FLAGLER COUNTY

TECHNICAL REVIEW COMMITTEE COMMENTS

RESUBMITTAL FOR SITE DEVELOPMENT PLAN IN A PUD (PLANNED UNIT DEVELOPMENT) DISTRICT – COQUINA COMMONS

Project #: 2023020081

GRADING, PAVING AND DRAINAGE PLAN

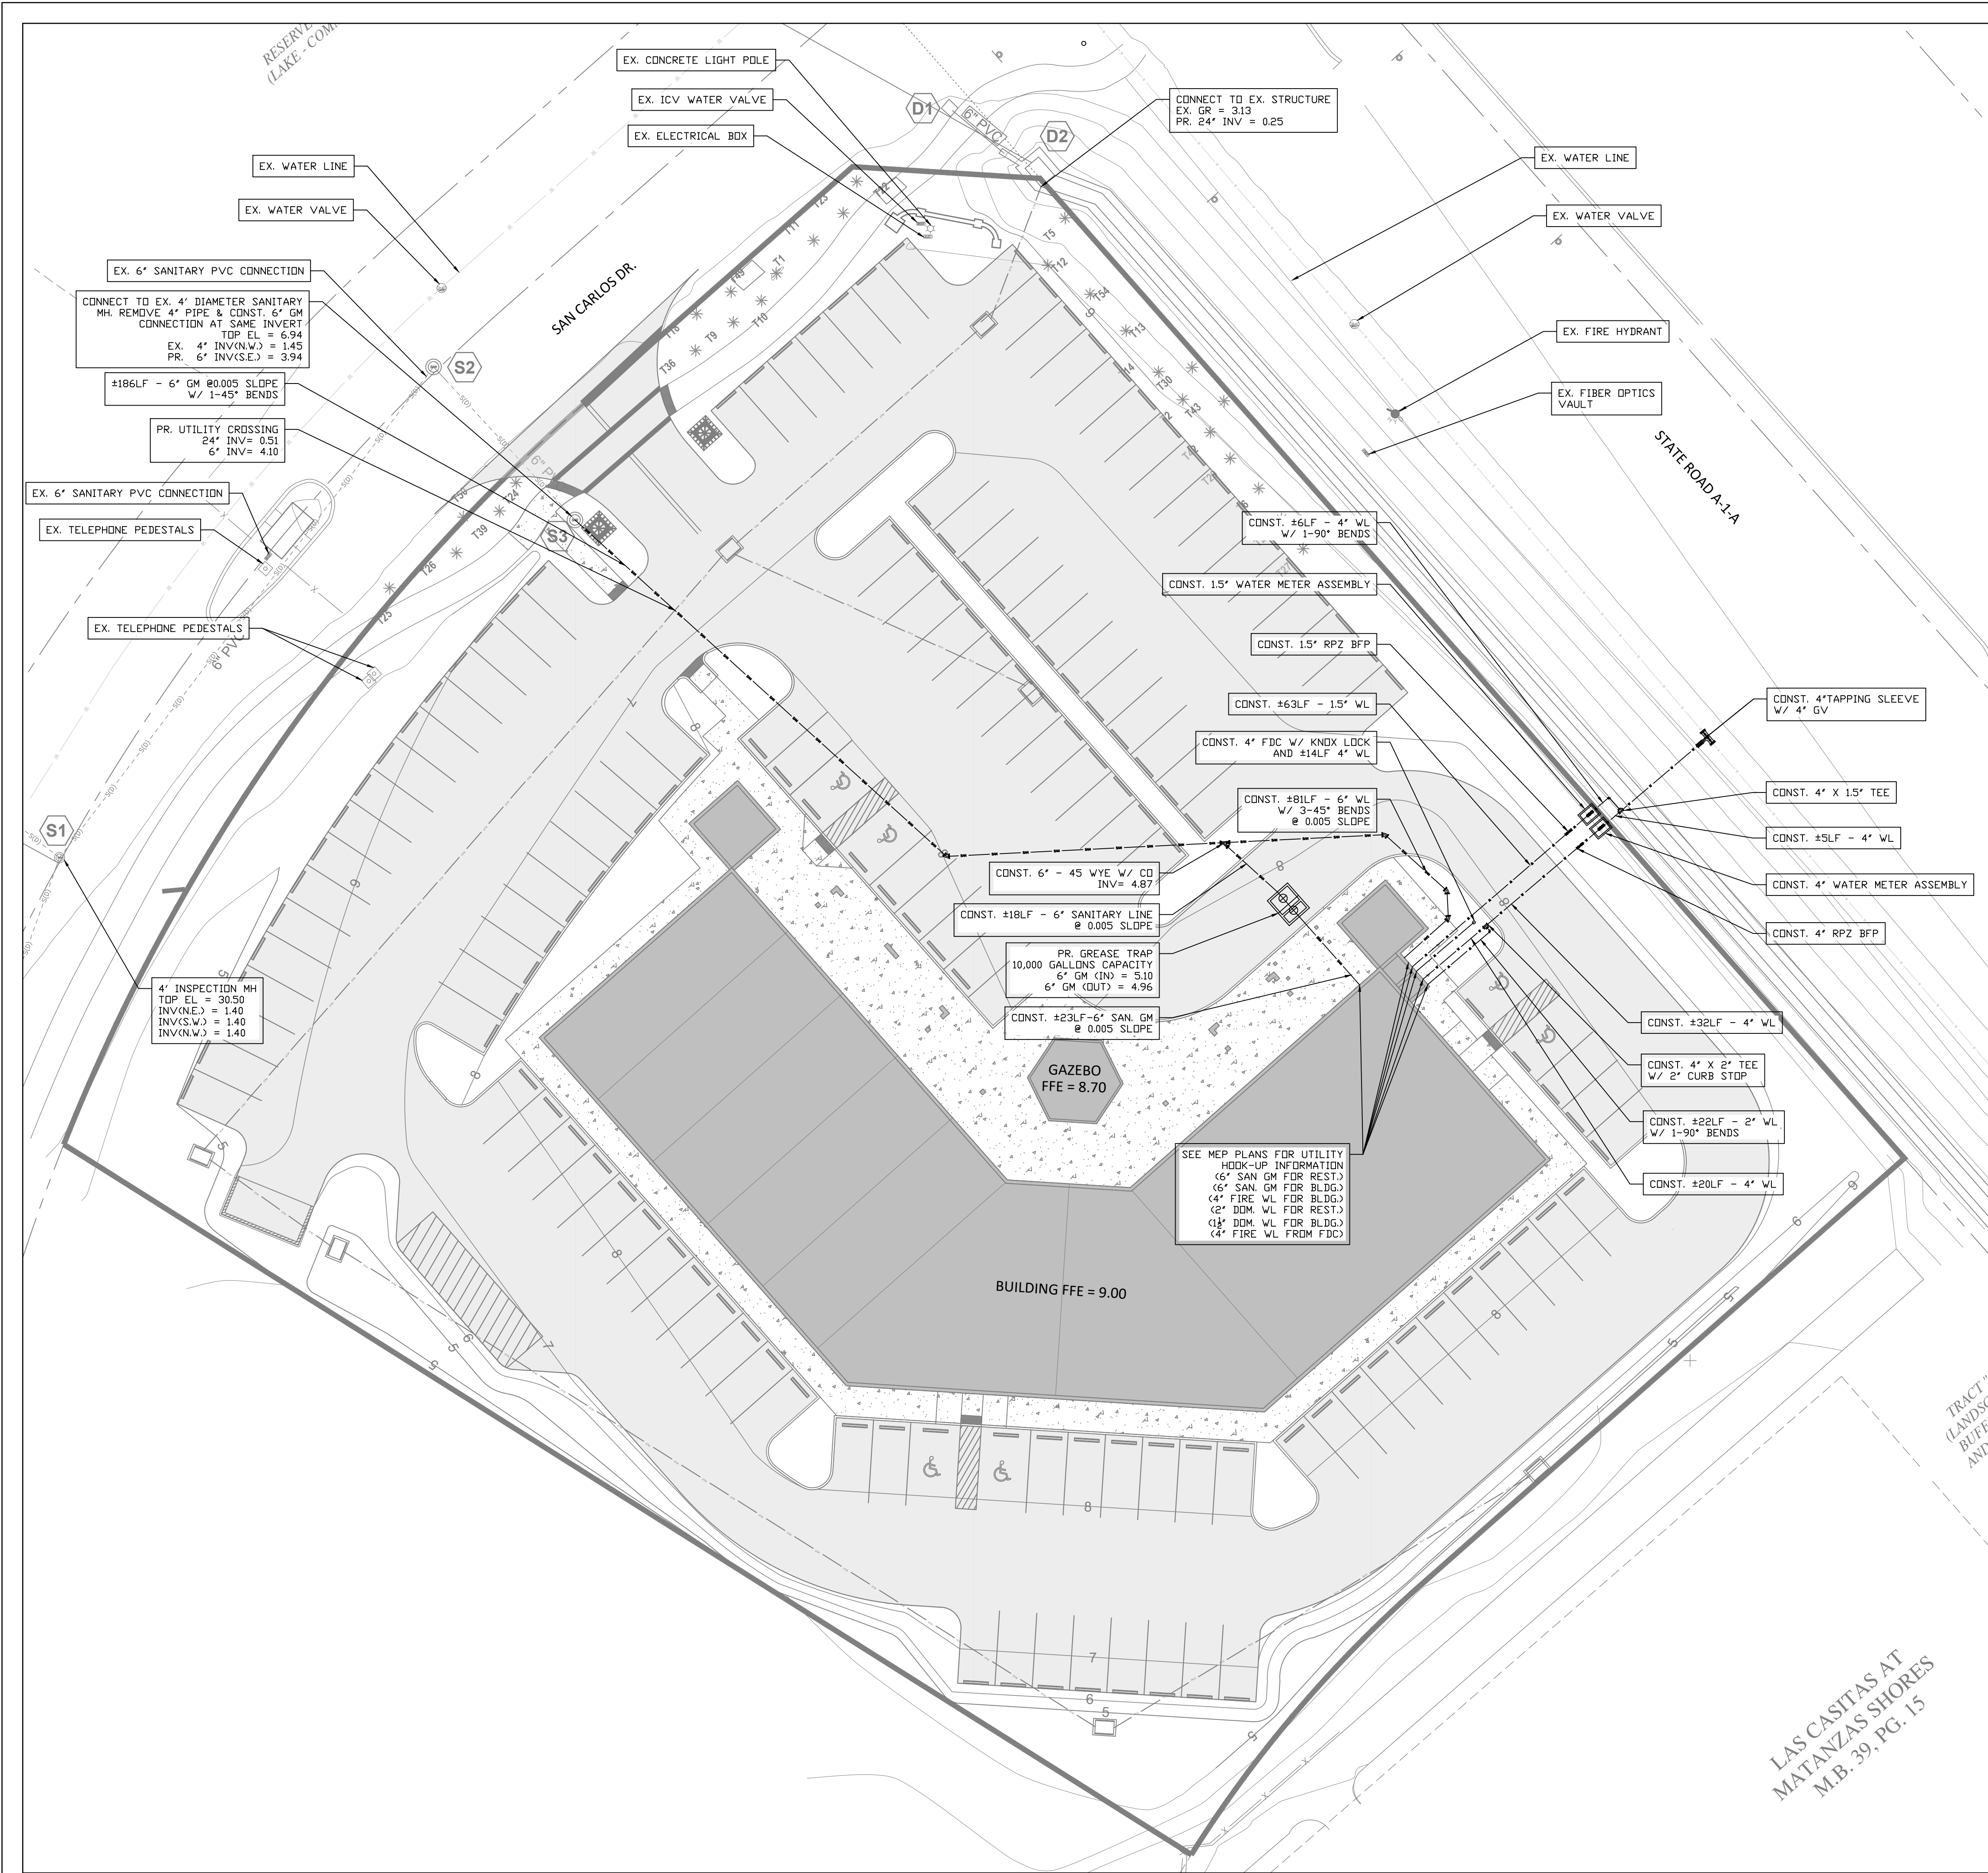
7. The building called out on sheet 6 in the front is also called out as a gazebo on sheet 5. If it is a building it should also be included in the site data table.

8. The existing inlets to remain should be identified as such on the grading plan.

9. The site will drain onto the adjacent property along the southern property line. Provide additional grading along the south and west sides to ensure the runoff is contained within the site.

Please see Sheet 6 for the updated call out, identifying it as a Gazebo.

Please see Sheet 6 for the updated call out.

As discussed at the April 19th TRC, the site is designed to capture runoff and direct to regional ponds per approved SJRWMD Permits. The proposed plan will actually alleviate ponding that currently occurs along the property line.
